TECHNICAL MEMORANDUM NO. 1

ADDENDUM TO FINAL PHASE 1 RFI/RI WORK PLAN

ROCKY FLATS PLANT
WALNUT CREEK PRIORITY DRAINAGE
OPERABLE UNIT NO. 6 (OU 6)

December, 1992

FIGURE 2

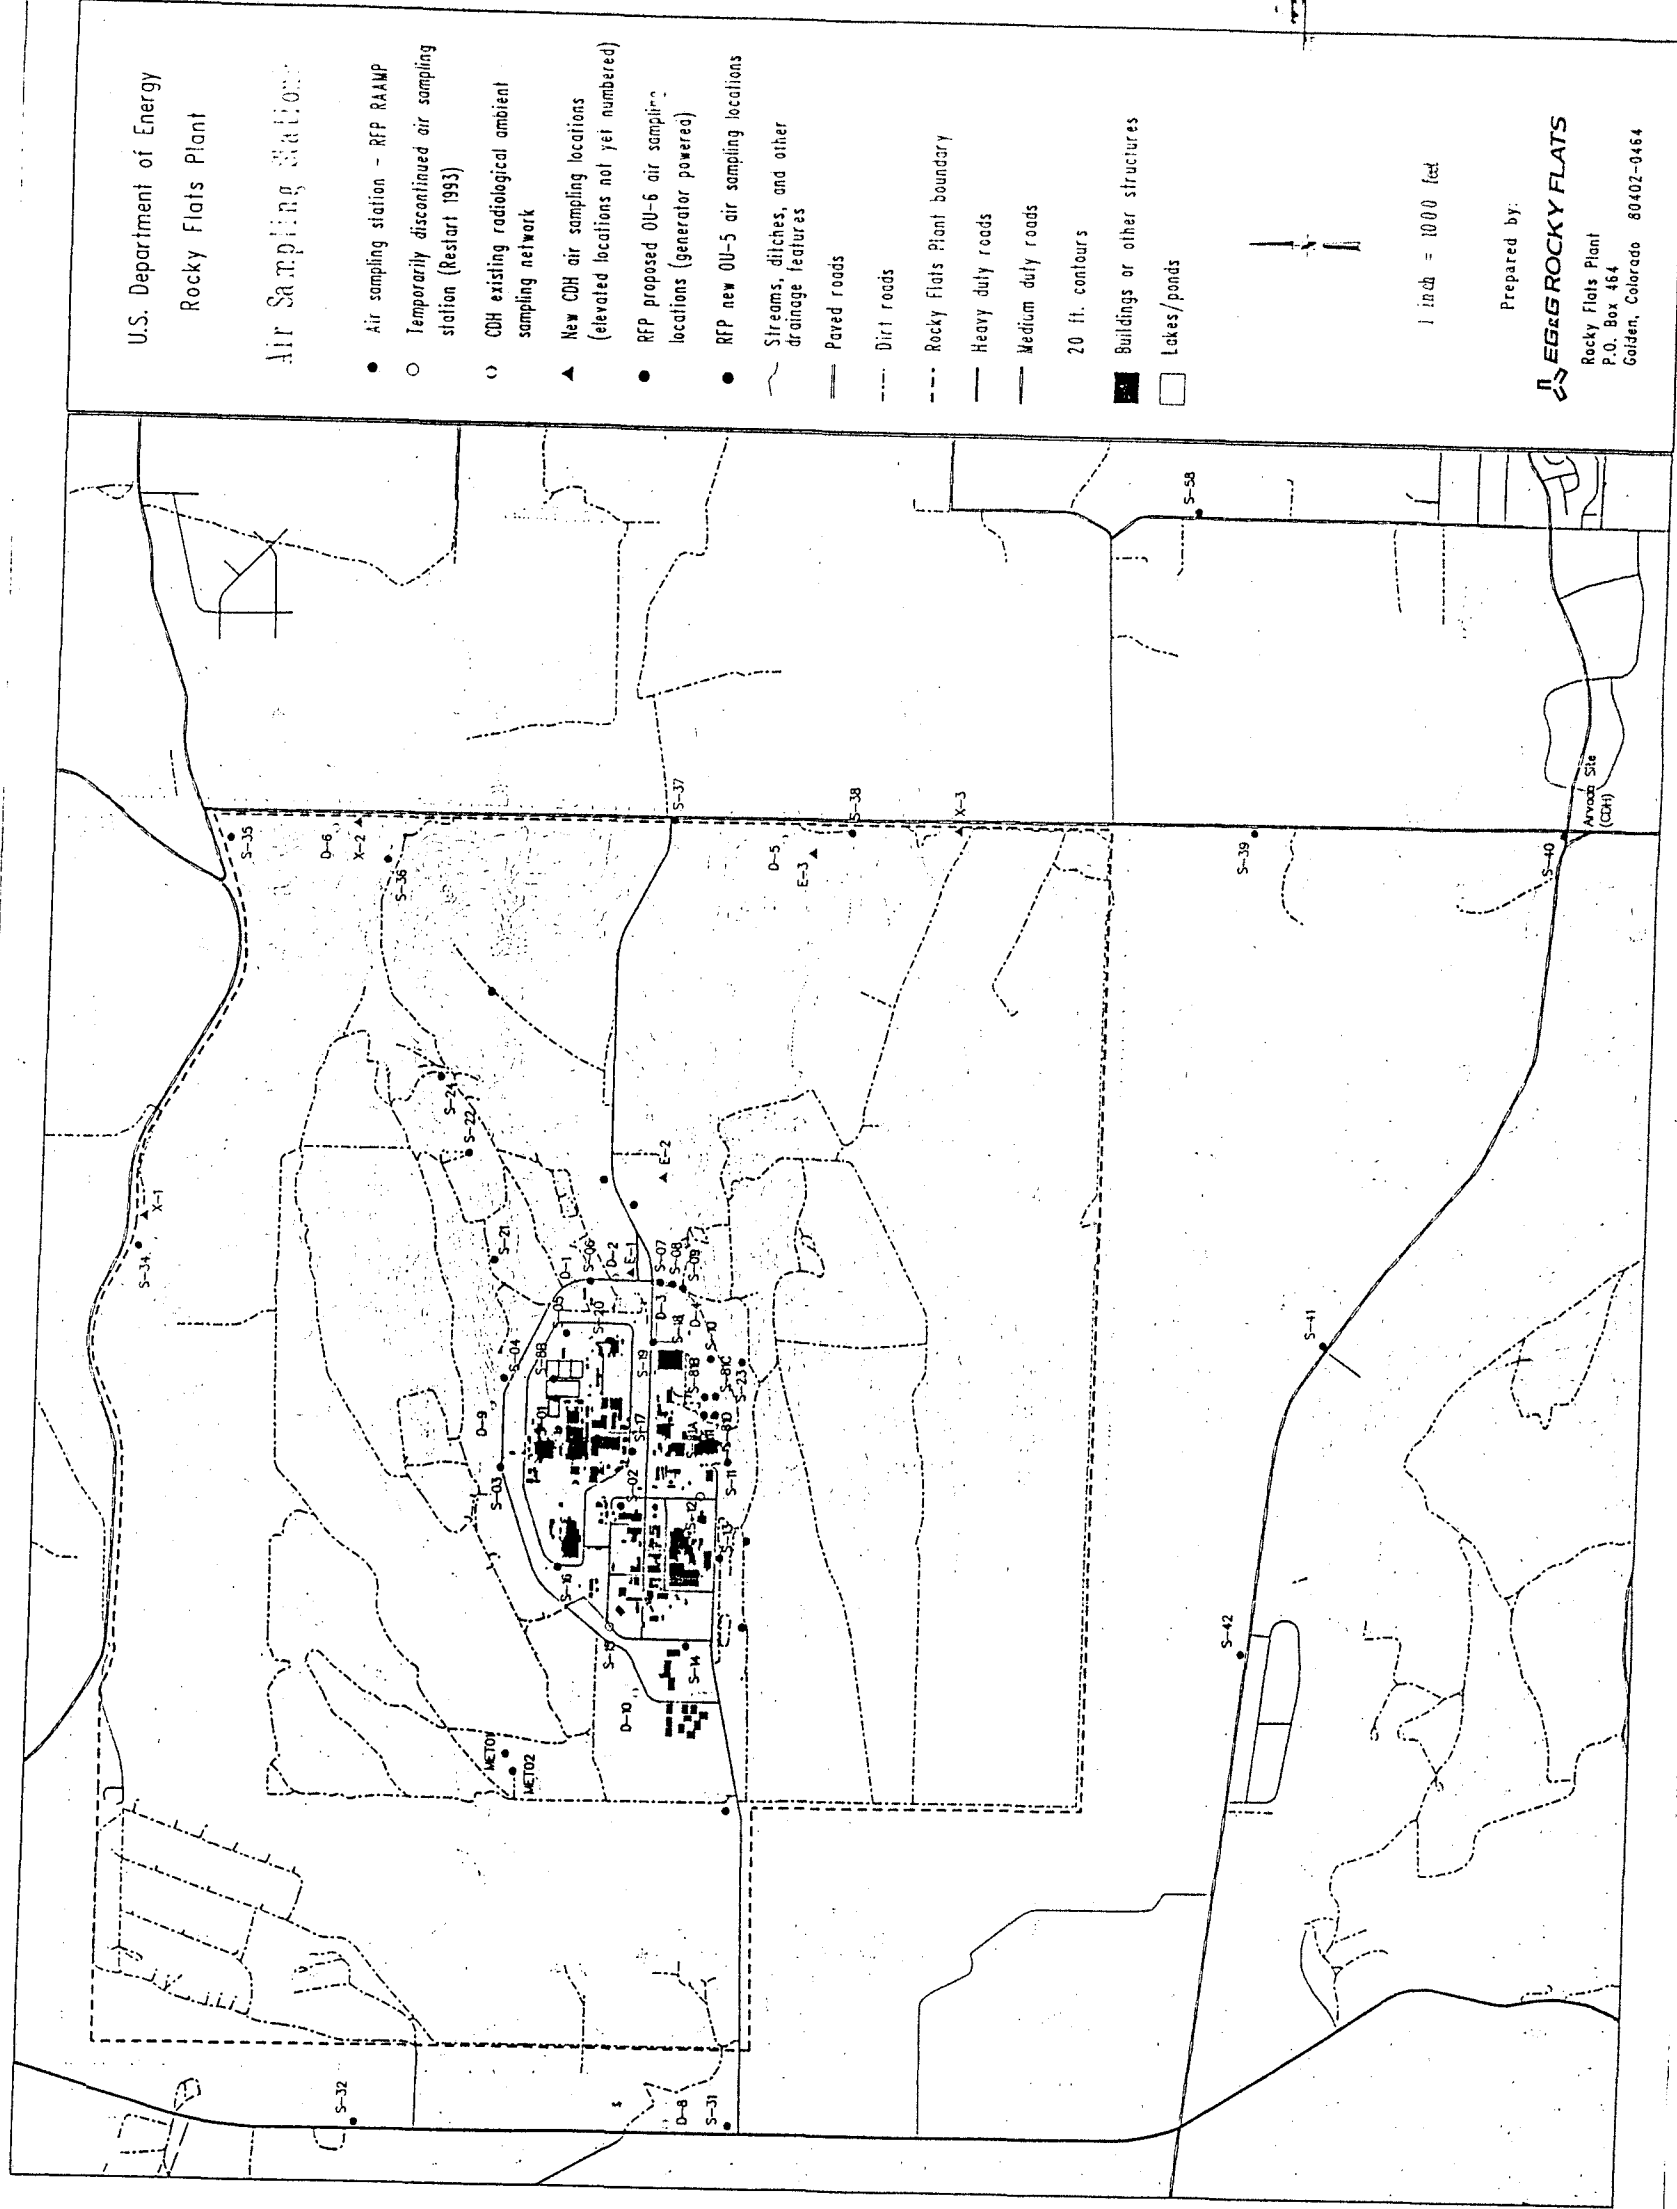
The three proposed ambient air samplers specified in Section 7.2.9 of the Work Plan are deleted. Short term and worker protection air sampling will be performed as indicated in the Plan for Prevention of Contaminant Dispersion (PPCD) and site specific health and safety plans.

Baseline ambient data for this OU will be obtained from the existing plant site Radiological Ambient Air Monitoring Program (RAAMP), which includes samplers in the Walnut Creek drainage and units at downwind locations S-35, S-36, S-37, S-38, and S-39 (Figure 2). In addition to the RFP sampling effort, CDH operates ambient air samplers in the vicinity of this OU and at downwind locations (D-5, D-6, E-2 and E-3, X-1 and X-2). Data from these sources will be used to evaluate the radioactive ambient emissions and perform an air pathway analysis.

FIGURE 3

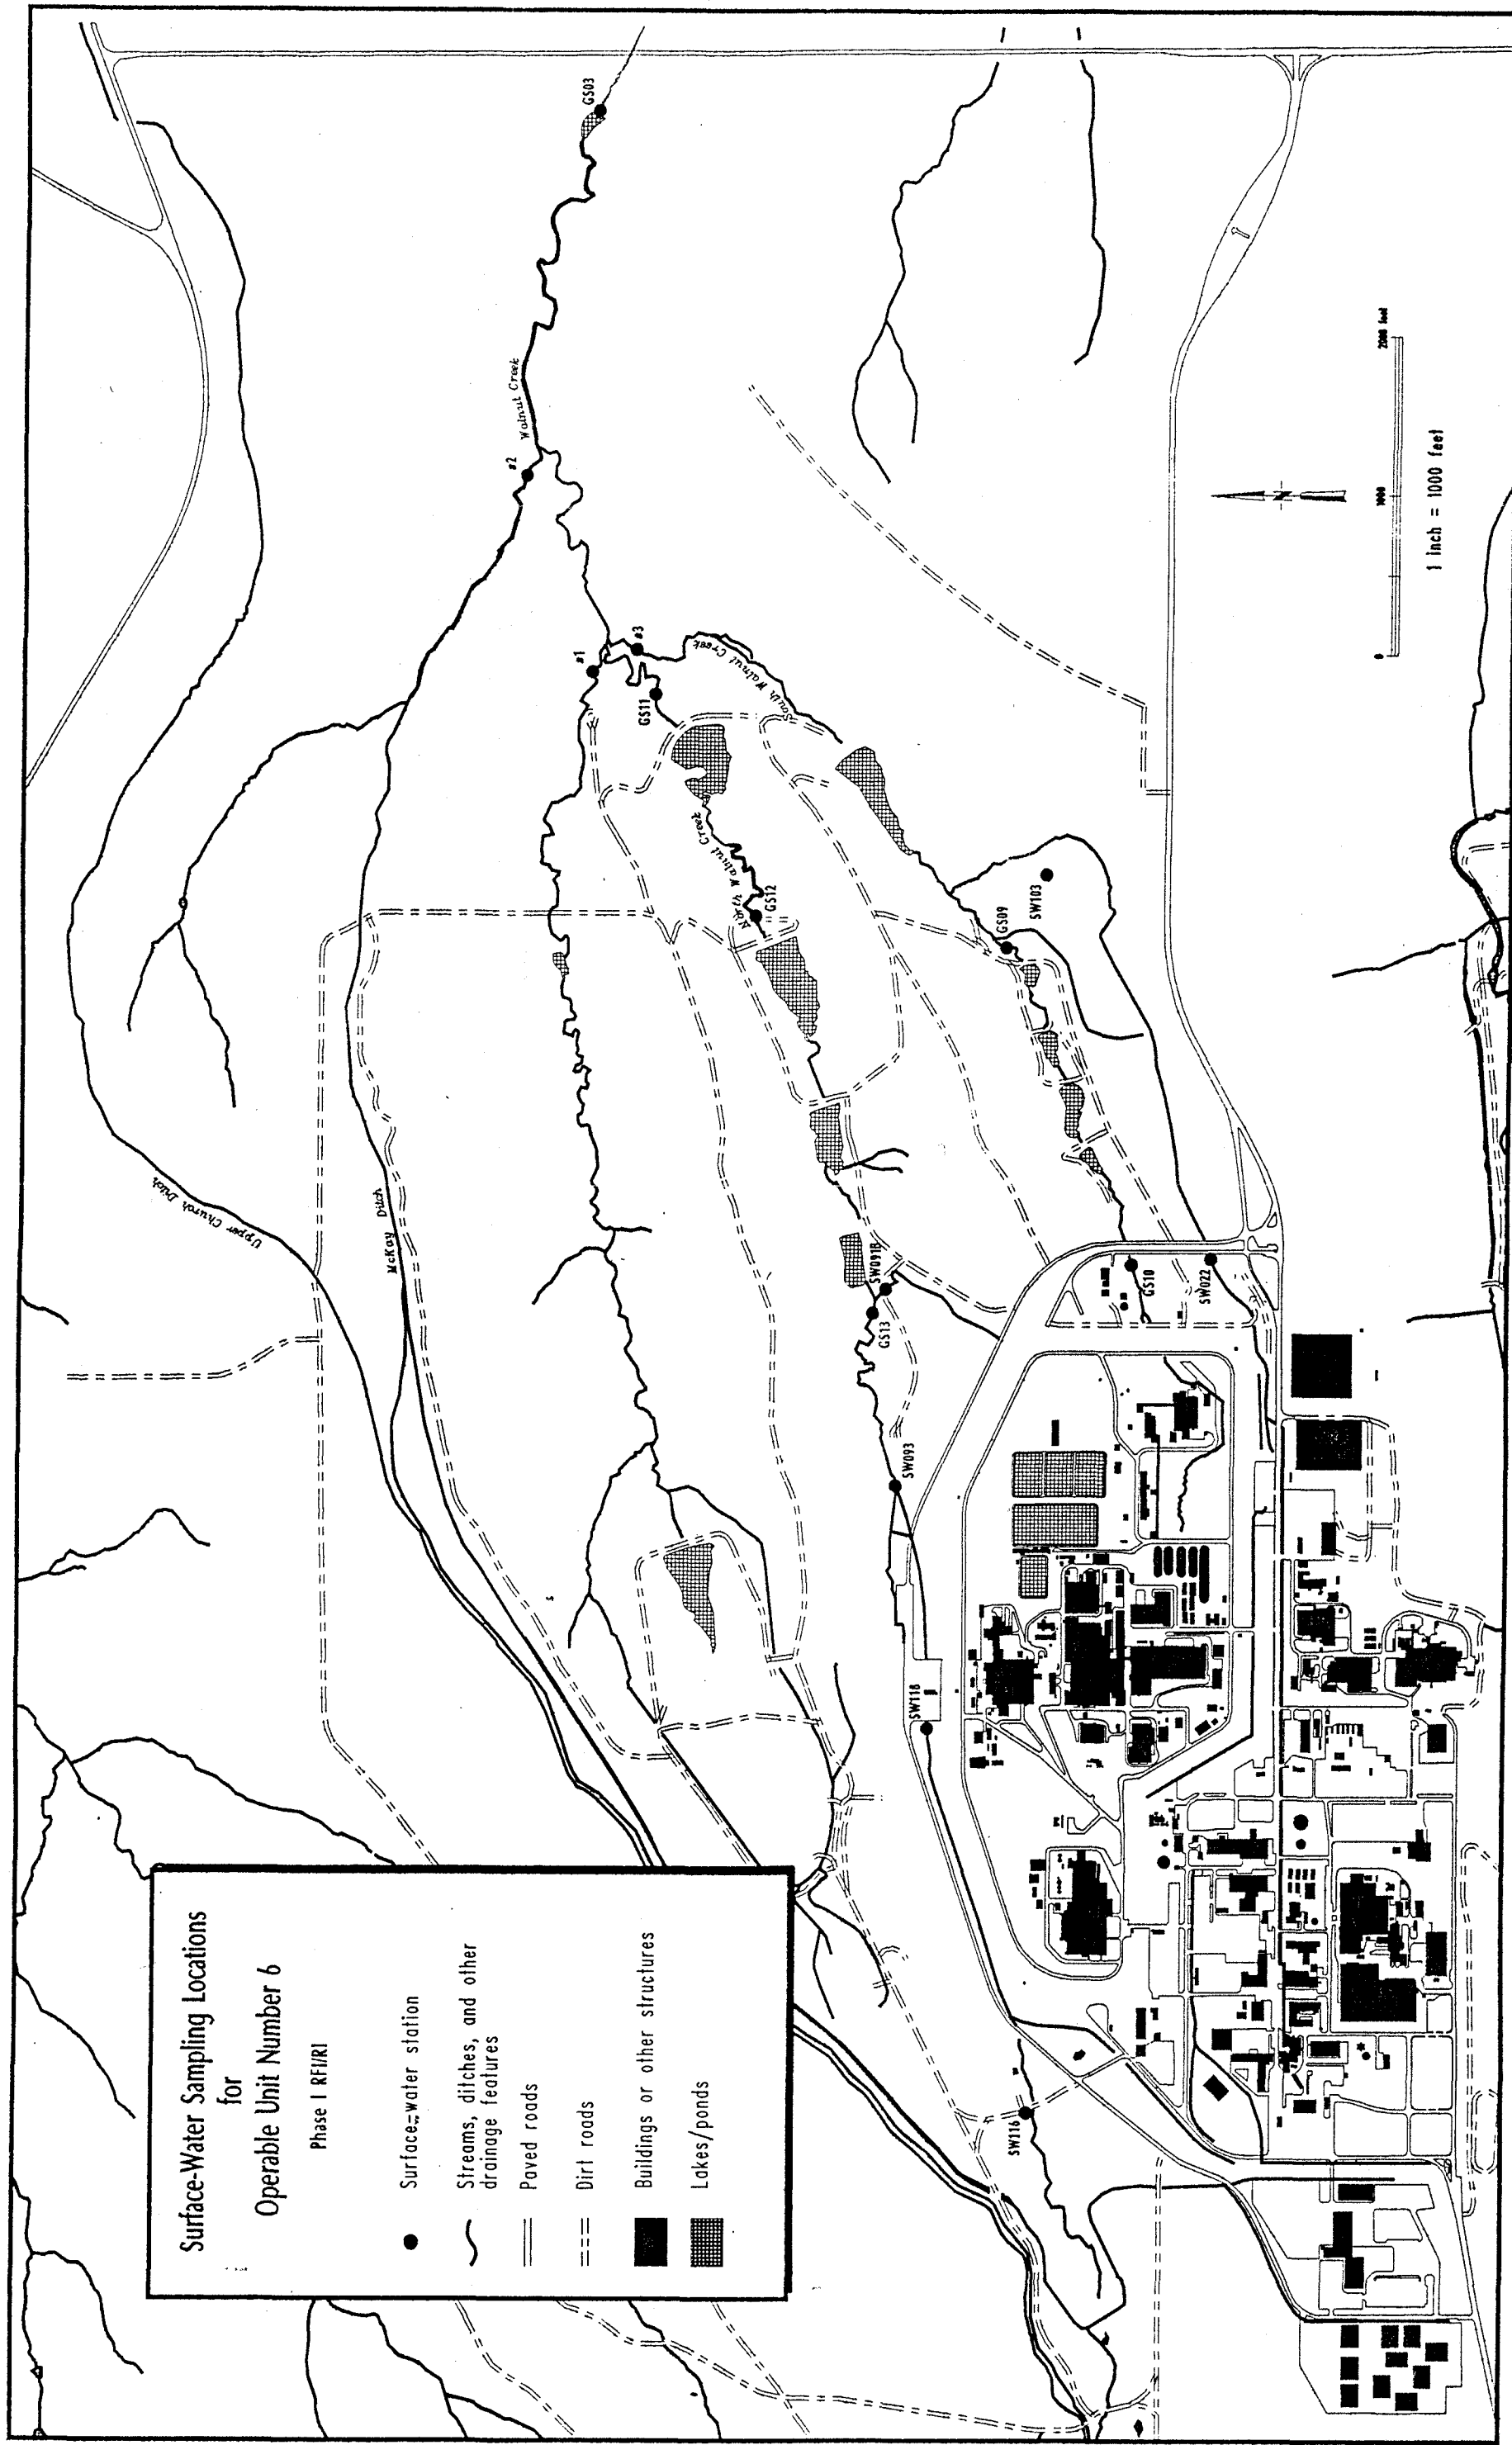
To adequately characterize the Walnut Creek Drainage, surface water samples will be obtained concurrently with sediment samples from the streams and at gauging stations shown on Figure 3. Contemporaneous flow measurements, and aquatic toxicity samples will also be obtained.

One sediment sampling event and two water sampling events will take place. One of the water sampling events will be during base flow conditions in the areas where flowing water can be measured and sampled. The second water sampling event will take place during a storm event or substantial snow melt of sufficient magnitude to provide measurable runoff. The sediment sampling event will be performed during the base flow conditions.

Surface water and sediment sampling will be performed according to EMD Operational Procedures Manual No. 5-21000-OPS-SW Volume IV: Surface Water. The sampling locations and the data to be acquired are summarized in Table 2.
